2018-12-07 DP AMENDMENT REVISIONS

The following is a summary of design revisions since the last DP Submission dated July 25, 2018.

IVY ON THE PARK

DP AMENDMENT SUBMISSION

FLOOR PLAN - TOWER -
LEVELS 03-10

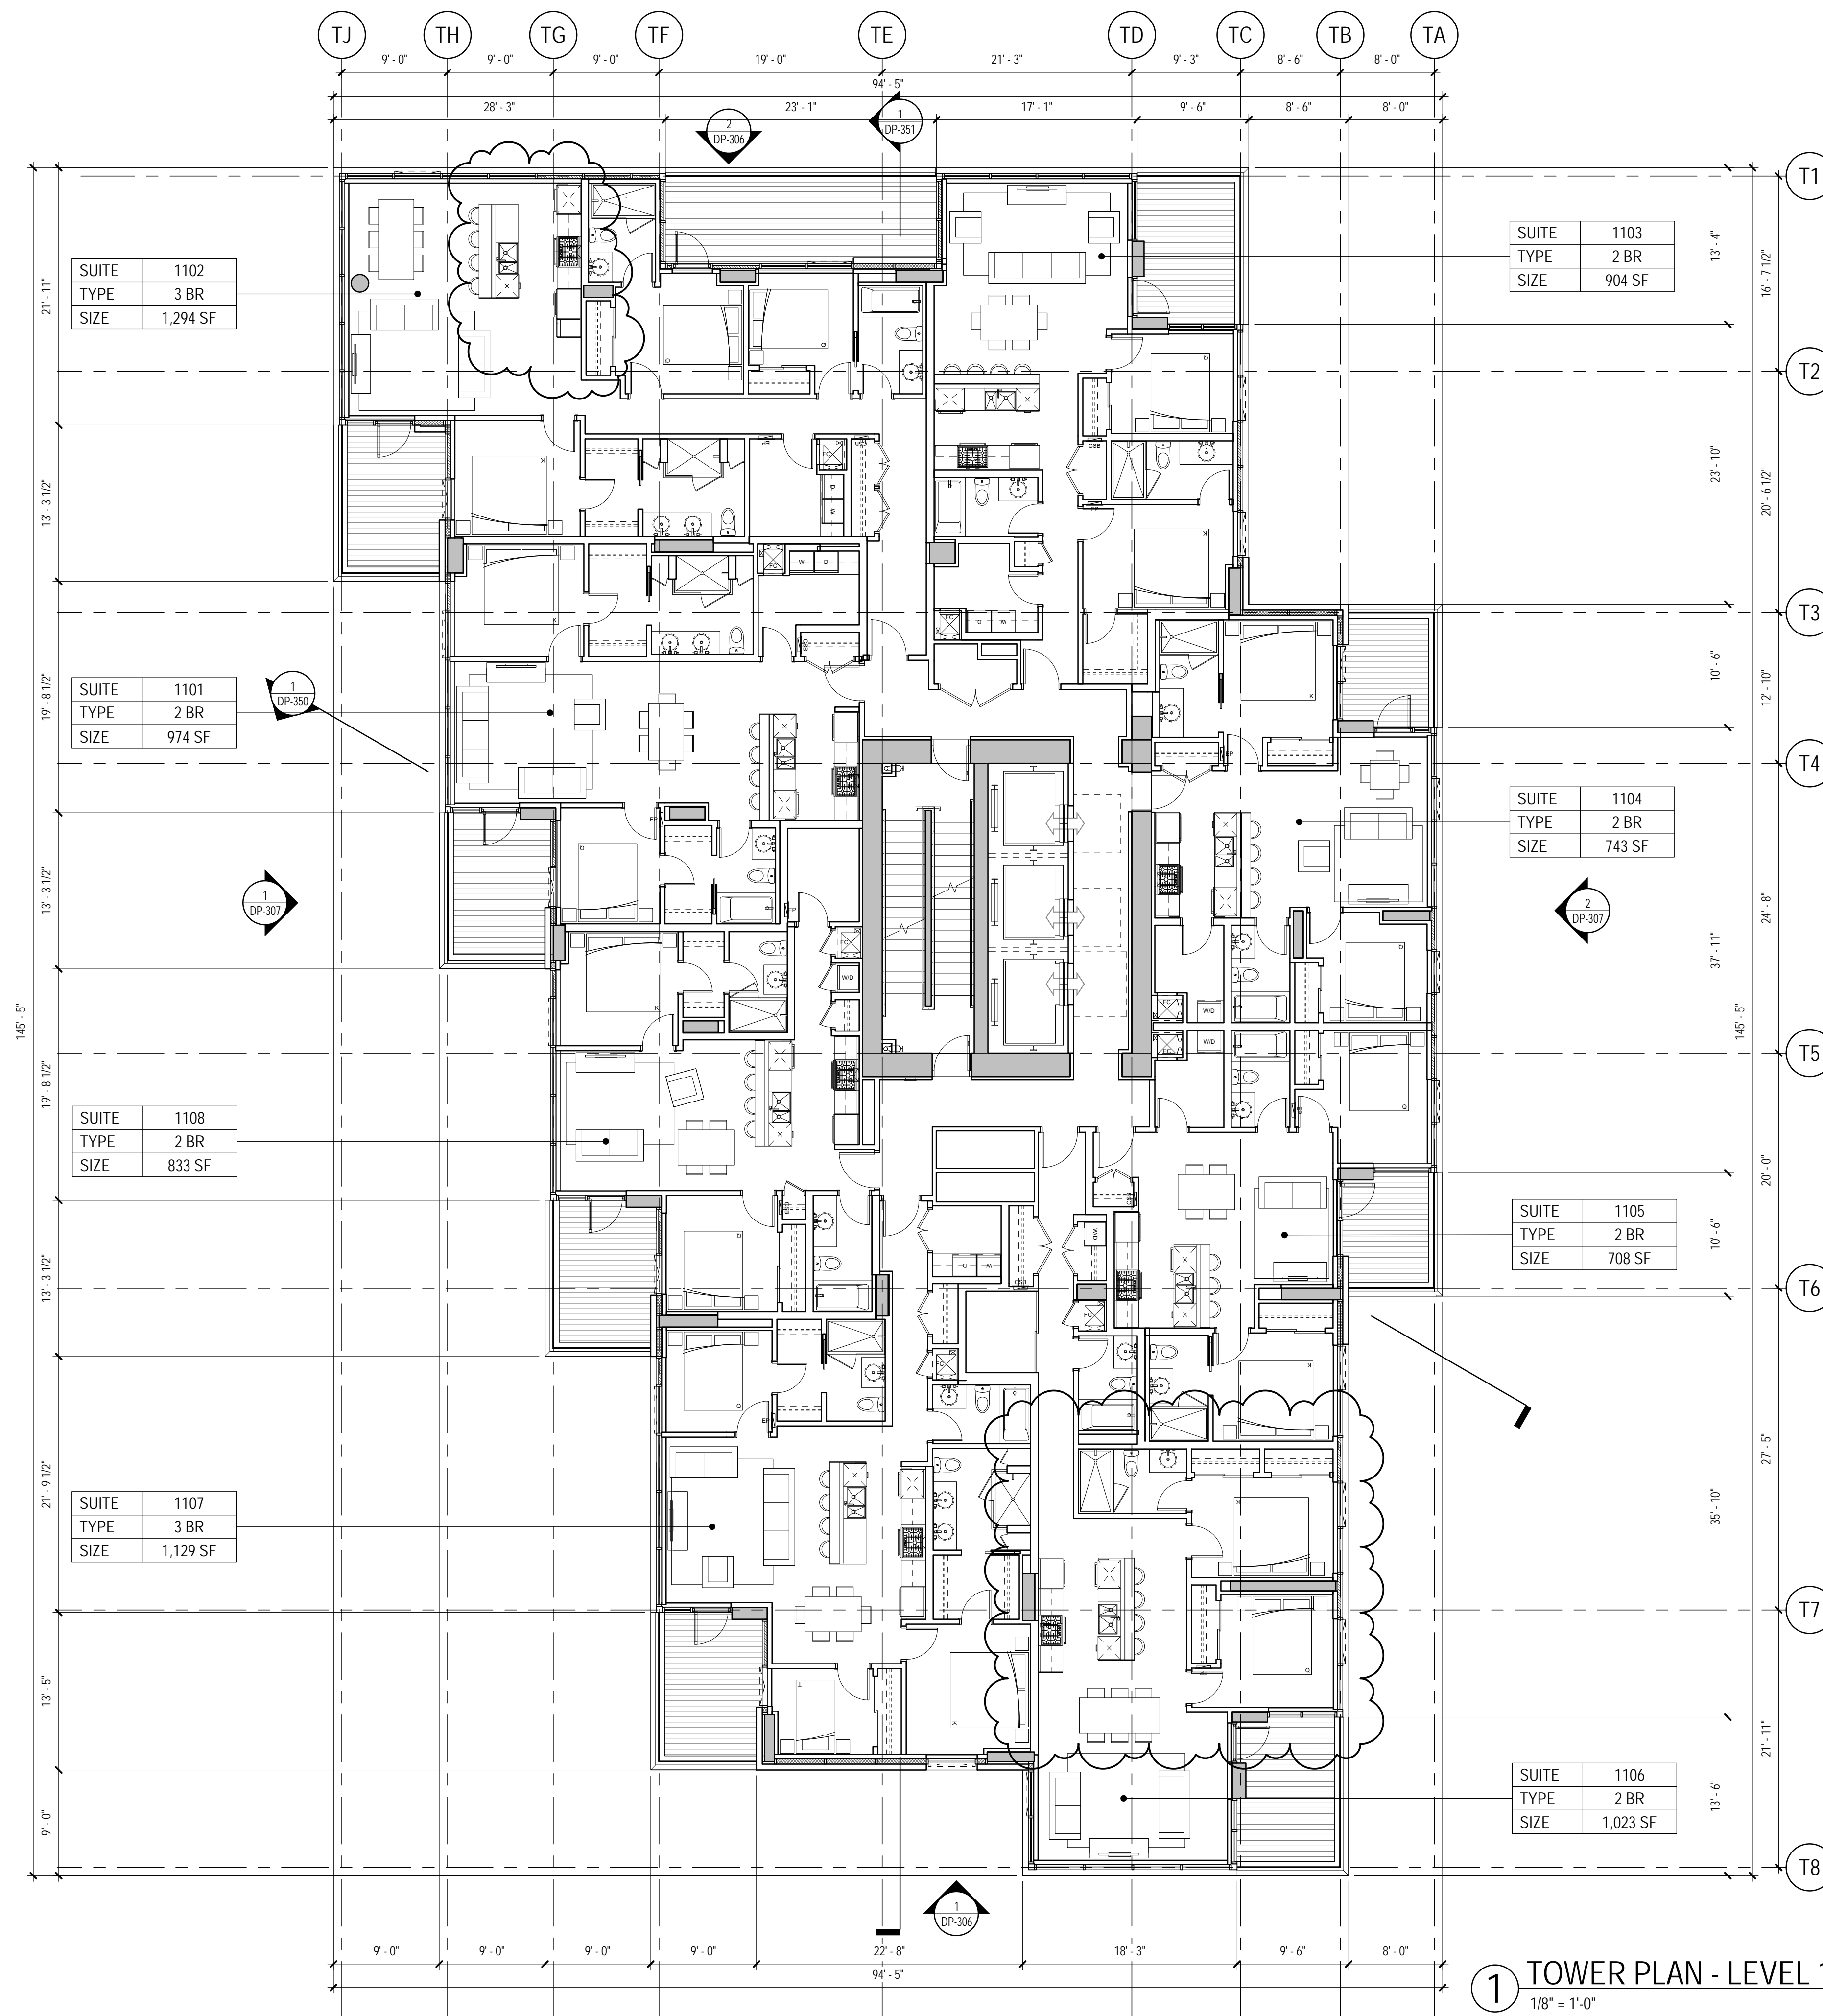
- Tower Level 2 – Kitchen and ensuite location revised in Suite 206 (change applies to levels 2 – 21).
- Tower Levels 3-10 – 2 bedroom unit at North-West end of tower replaced with one 1 bedroom suite and one Studio suite. Some balcony reclaimed at north end by the Studio suite. A Juliet balcony provided to the Studio suite.

- Additional common corridor/vestibule added to provide access to the revised suites.
- Tower Levels 11-21 – Suite 1102 kitchen revised due to new column locations.

FLOOR PLAN - TOWER -
LEVEL 22

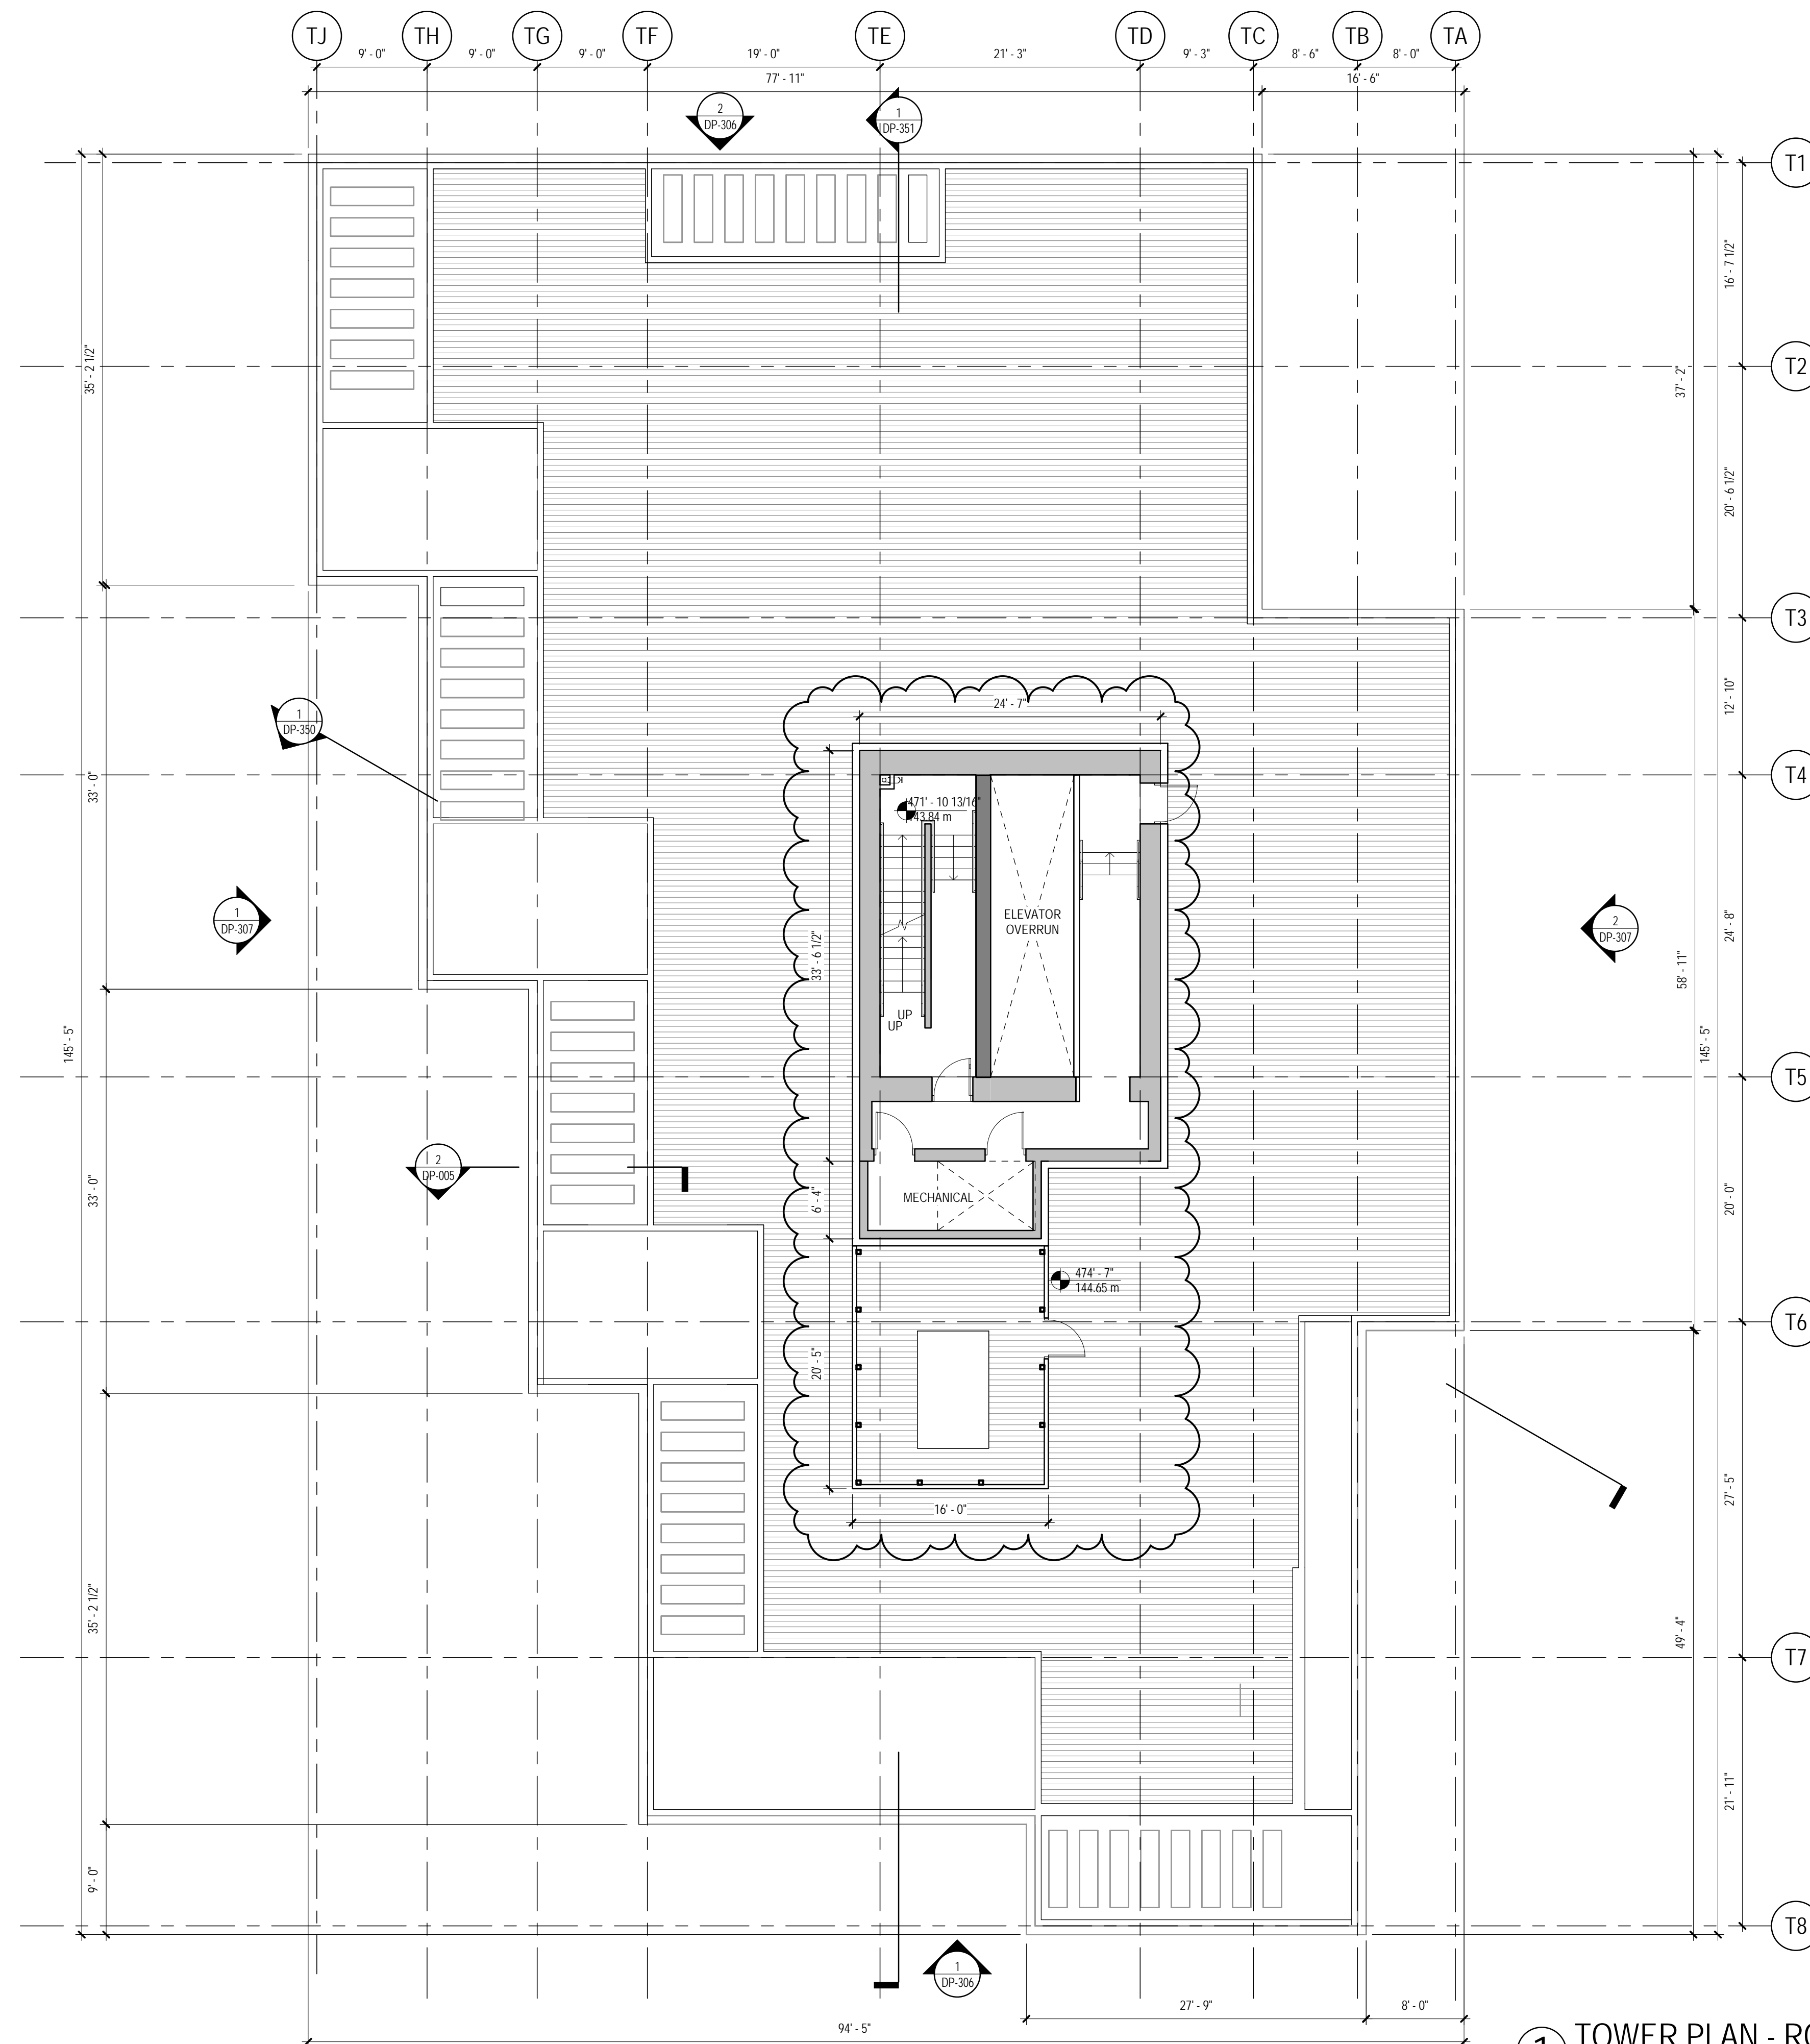
- Tower Level 22 – Additional fancoil units added to Suite 2203 and 2204.
- Roof – Corrugated metal cladding around building elements on roof.
- Steps added to provide roof access. Doors to roof revised.
